From:	c.campbell.architect
To:	Iksun Yang
Cc:	Kim Munro
Subject:	Re: BCO10364430-A, 362 Matakana Valley Road Matakana - 1st RFI follow up
Date:	Friday, 24 May 2024 9:28:02 am
Attachments:	240523 REPLACEMENT MARKET SHEDS.pdf image001.png image002.png

From: Iksun Yang <Iksun.Yang@aucklandcouncil.govt.nz>
Date: Thursday, 23 May 2024 at 9:54 AM
To: c.campbell.architect <c.campbell.architect@xtra.co.nz>
Cc: kimmunro362@gmail.com <kimmunro362@gmail.com>
Subject: RE: BCO10364430-A, 362 Matakana Valley Road Matakana - 1st RFI follow up

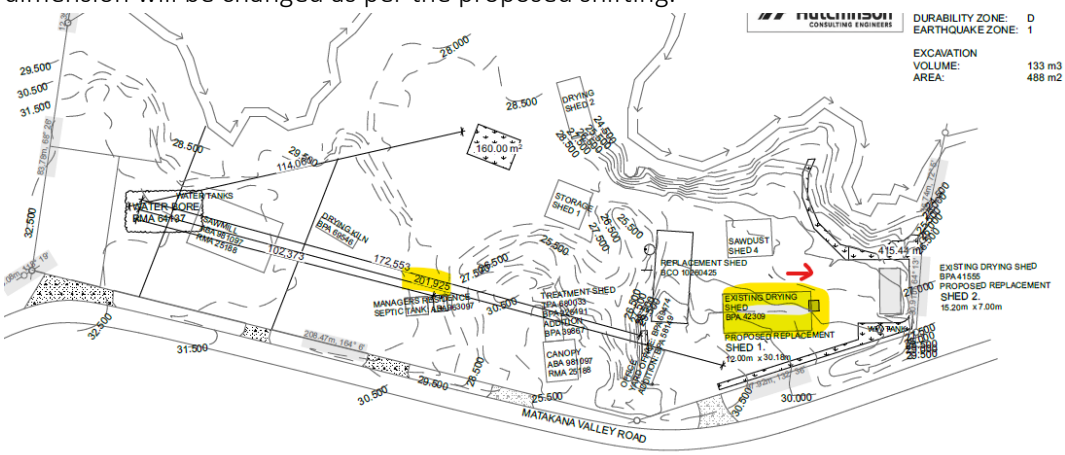
As per the approved site plan, the siting dimensions indicated on sheet 100 and 101. And the dimension will be changed as per the proposed shifting.

So, the siting dimensions on sheets 100 and 101 need to be updated.

Hi Iksun,
Sheet 01.1 has been updated with the dimensions marked and dated today. I will also upload to the portal.
Regards

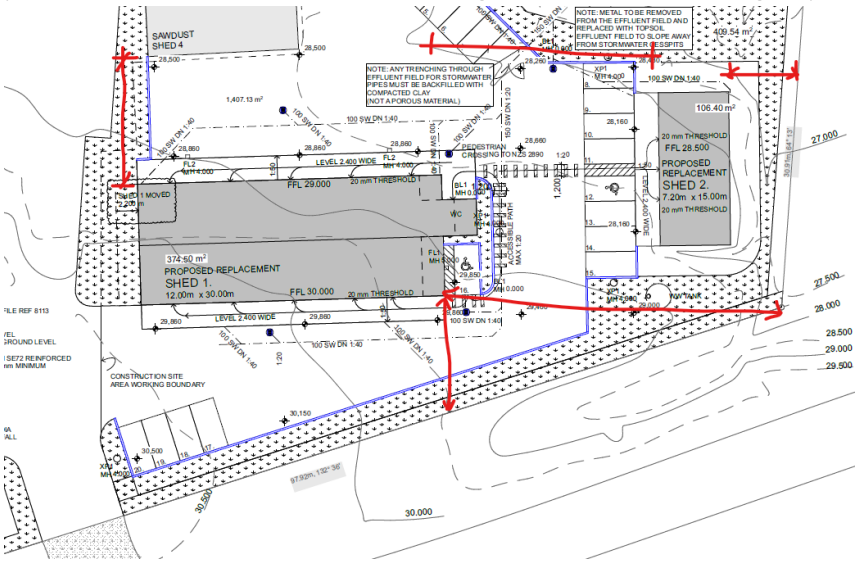
Or alternatively, you can add some siting dimensions on sheet 01.1 as this is the enlarged site plan, so we can have more correct siting dimension for building inspectors.
